Town of Apex North Carolina
P.O. Box 250
Apex, NC 27502
(919) 249-3426
www.apexnc.org

11/21/2024

RE: Tingen Corners (fka Seymour PUD) Master Subdivision Plan
Review No. 2

8. Subdivision Requirements

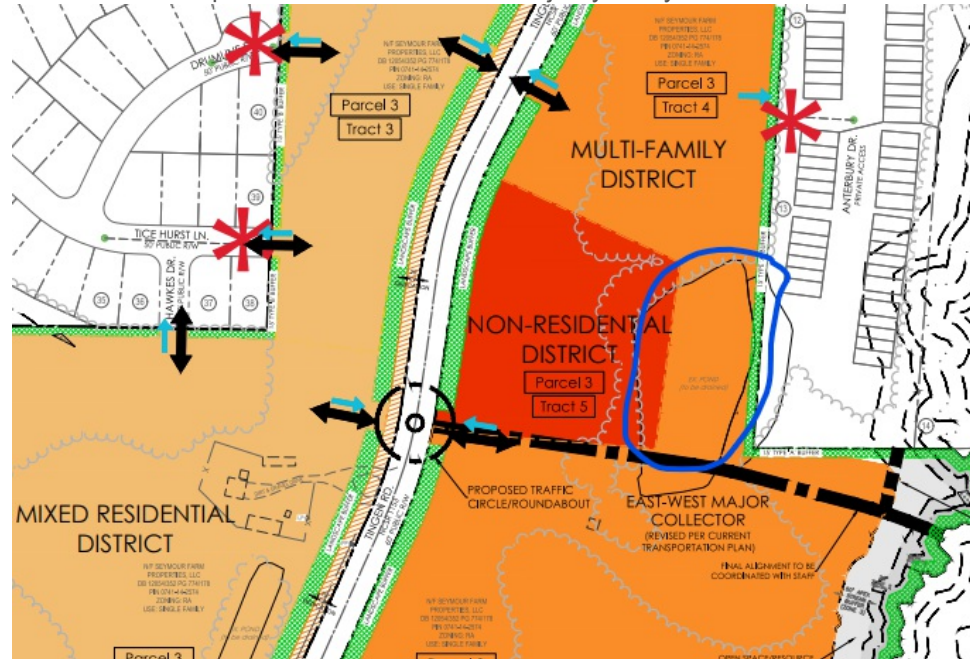
Please provide a separate RCA plan sheet to make it clear to staff what is being counted as RCA. The various hatching makes it a little difficult to follow.

11. General

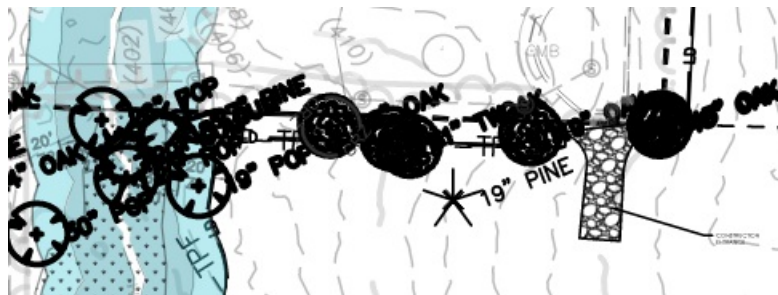
The maximum scale that we can review is 1:50. Please provide enlarged sheets that match the extent of the other plan sheet types.

It's regrettable that this requirement hasn't been enforced consistently. It is the policy and is stated clearly on the application. The current scale is making it difficult for staff to read and review the tree survey that's shown on the plans so that we can confirm that accurate and adequate measures are provided on the other sheets. below is a screenshot taken with the document enlarged to 100%. We can't tell how many trees are clustered together, what size they are, or if any of them are being removed.

Prev town submittals and approved plans have allowed the use of existing condition plans to be at scale greater than 50'

13. Demo Plan

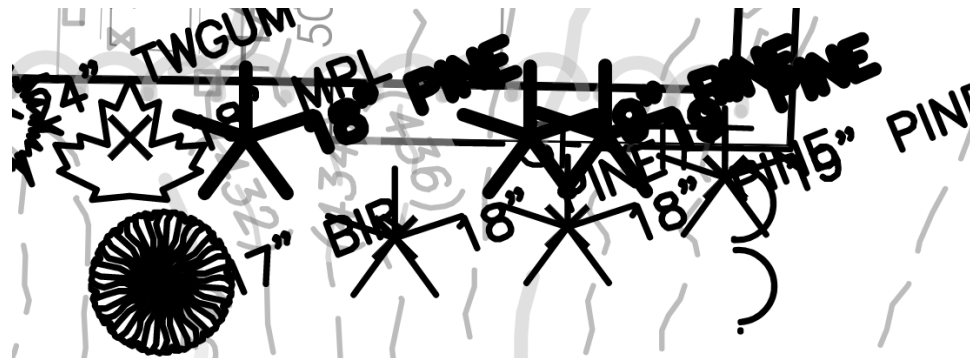
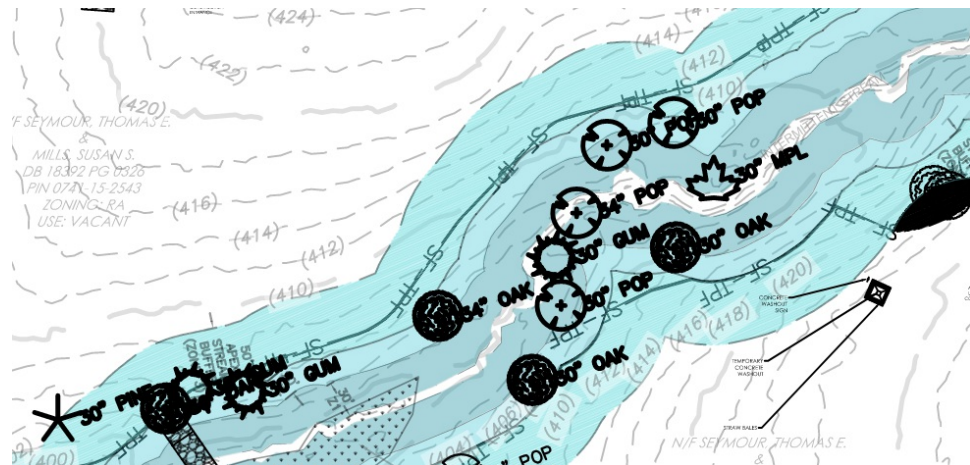
Please show the critical root zones on all trees to be kept. The radius of the critical root zone is 1 foot per 1 inch diameter at breast height. Where the CRZ is shown, it's shown half as large as it should be.

The CRZ is missing for several trees within the RCA and perimeter buffers. Please correct this. The two screenshots below are just 2 examples from the plans. there are more.

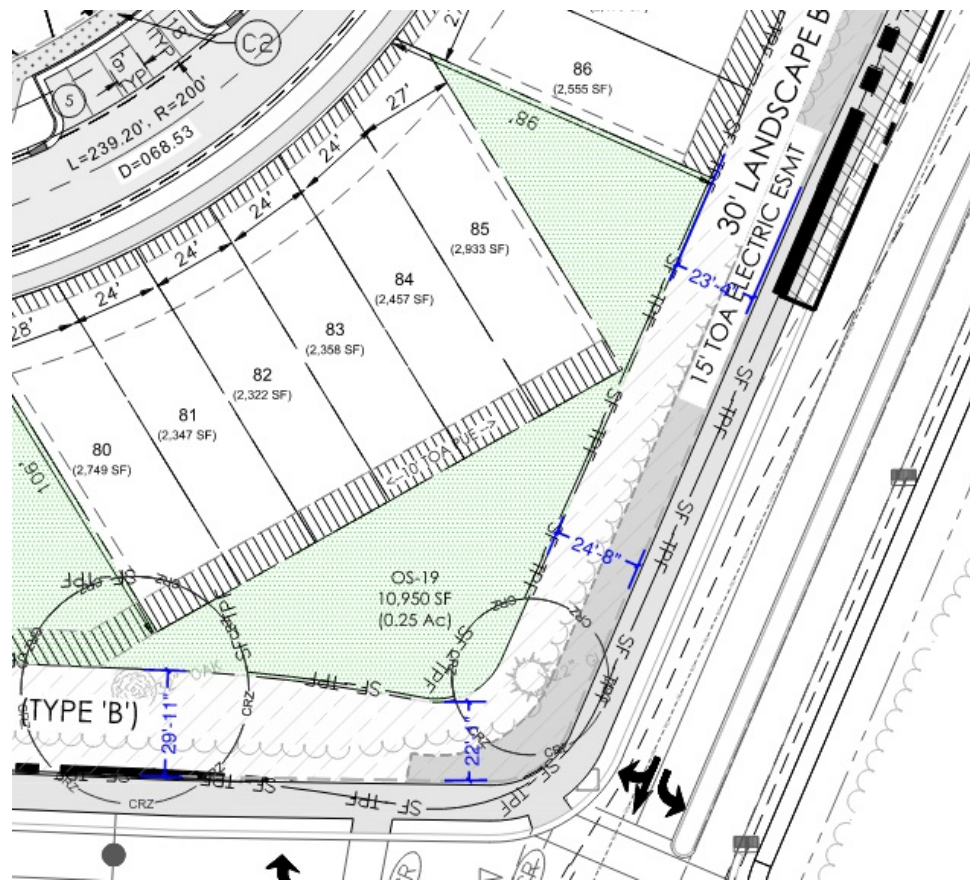
Please adjust your plans to meet this requirement. The buffer on the NW corner of Tingen Rd and the Peakway is only 23' wide, instead of the required 30'. Please adjust it.

The way it's drawn on the site plan, the ROW line isn't clear. I was under the impression, that the side path would be entirely within the ROW. Is the sidepath encroaching 5' into the buffer?

The Peakway R/W and buffer are consistent with the 30ft buffer along this section. Town required public access easement and side path line work may be causing some confusion here.

016_MSP L-1.3 PARTIAL LANDSCAPE PLAN-TR4.pdf [1 redline] (Page 1) [1] 016_MSP L-1.3 PARTIAL LANDSCAPE PLAN-TR4

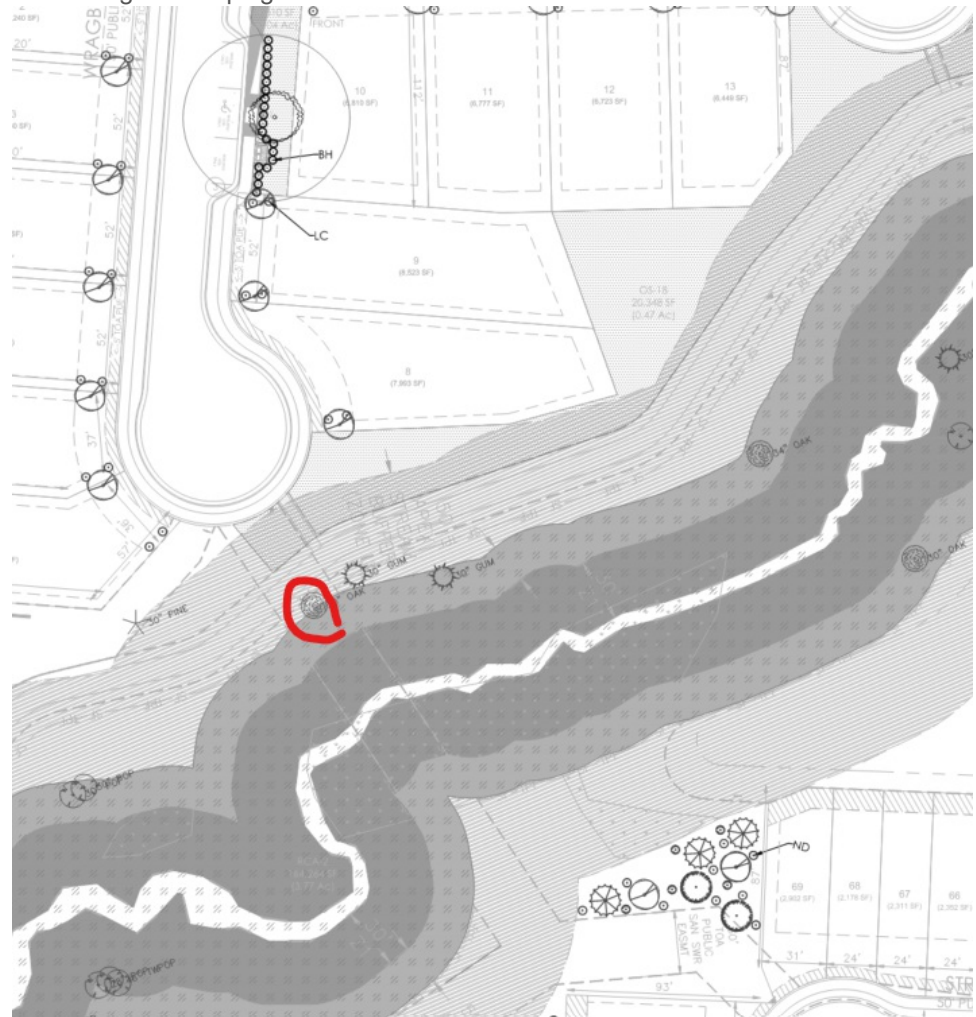
Still seeing landscaping in easements.

Peak Engineering & Design, PLLC Jeff Roach 10/4/24 8:37 AM Master Subdivision Plan - Residential - 1	Owner has been informed of the requirements associated with easements and encroachments.
---	---

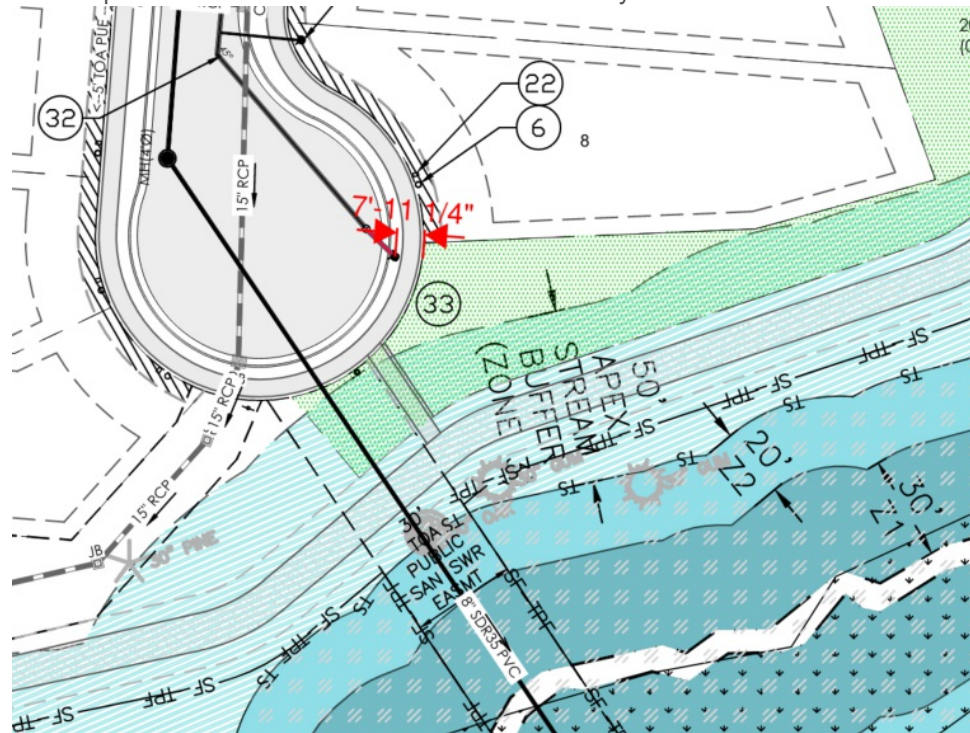
Easement for hydrant

Hydrant was moved to it's correct location behind back of curb

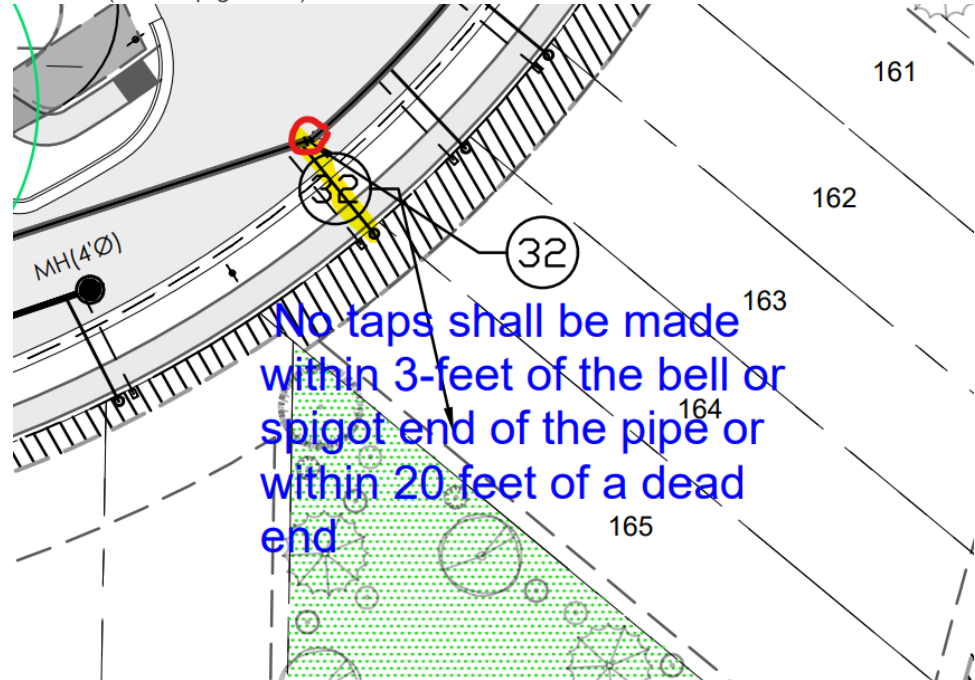
At bend (bell & spigot end)

92. Text Box B

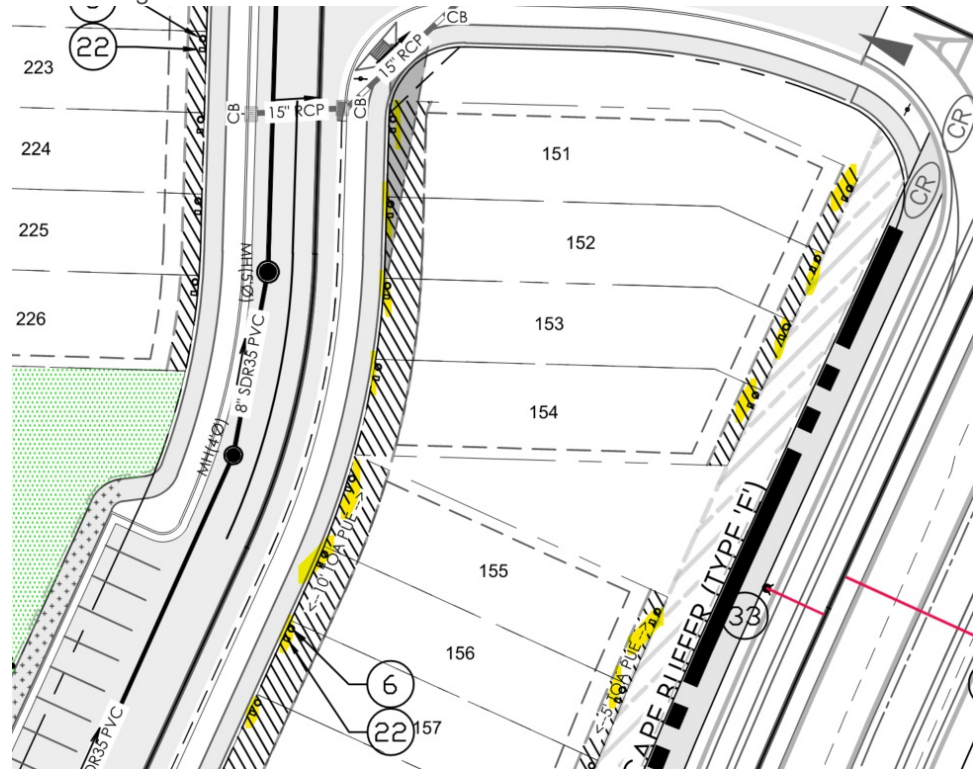
Still showing double services.

96. Additional easement needed B

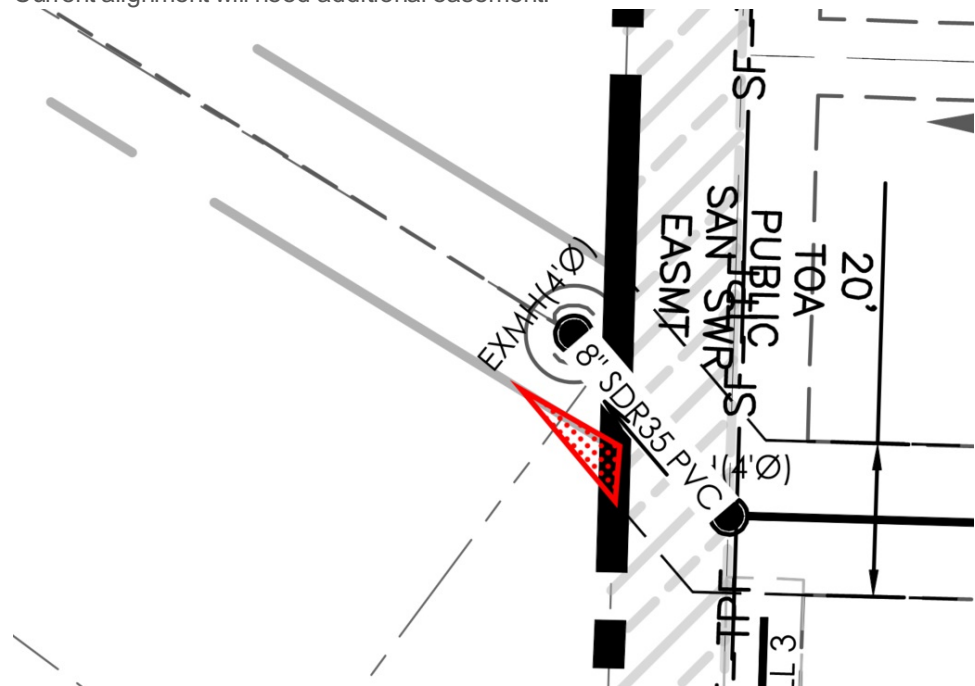
Town of Apex Public Sanitary Sewer Easement will need to be acquired,

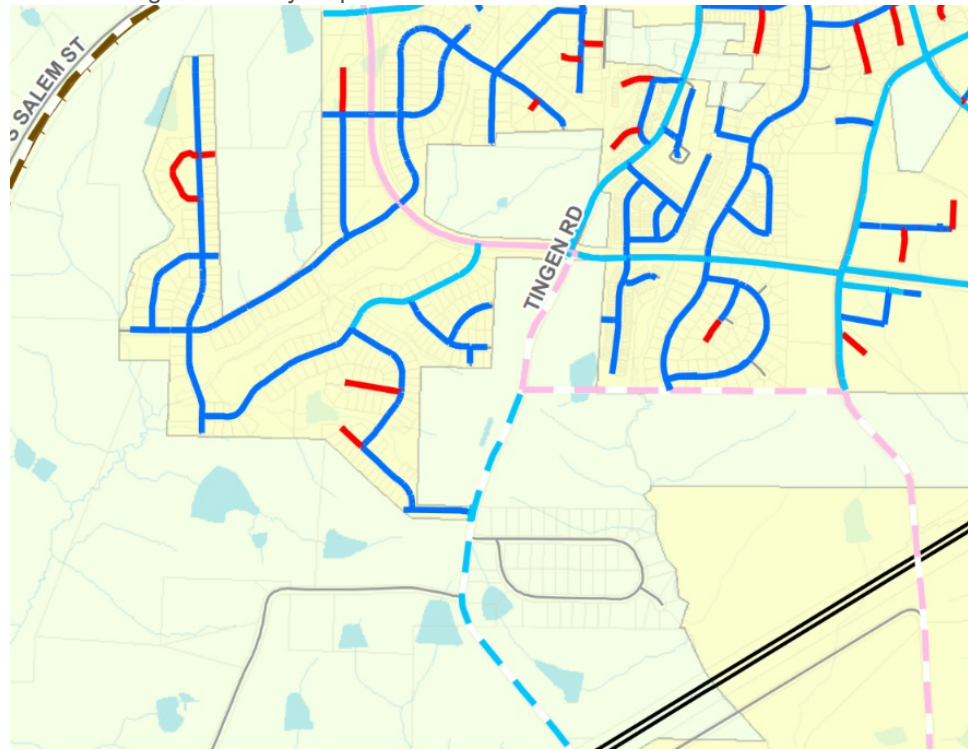
Water transmission lines shall be located and sized in accordance with the current "Water System Master Plan" or as directed by the Town, and shall extend to the adjacent properties to provide an adequate network.

103. Valves B

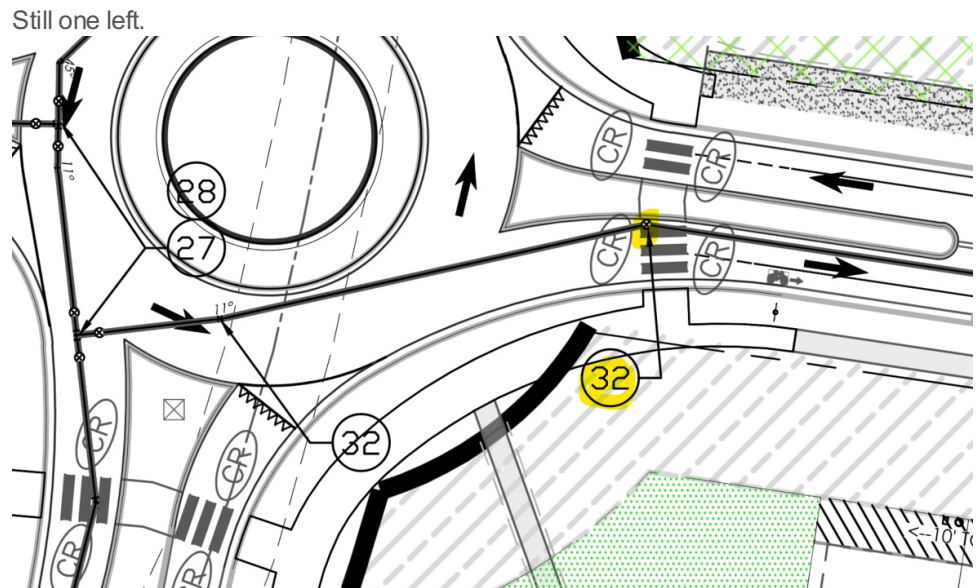
32 is a bend but you are showing symbol of a valve.
[Ver. 2] [Edited By Jackie Dillon]
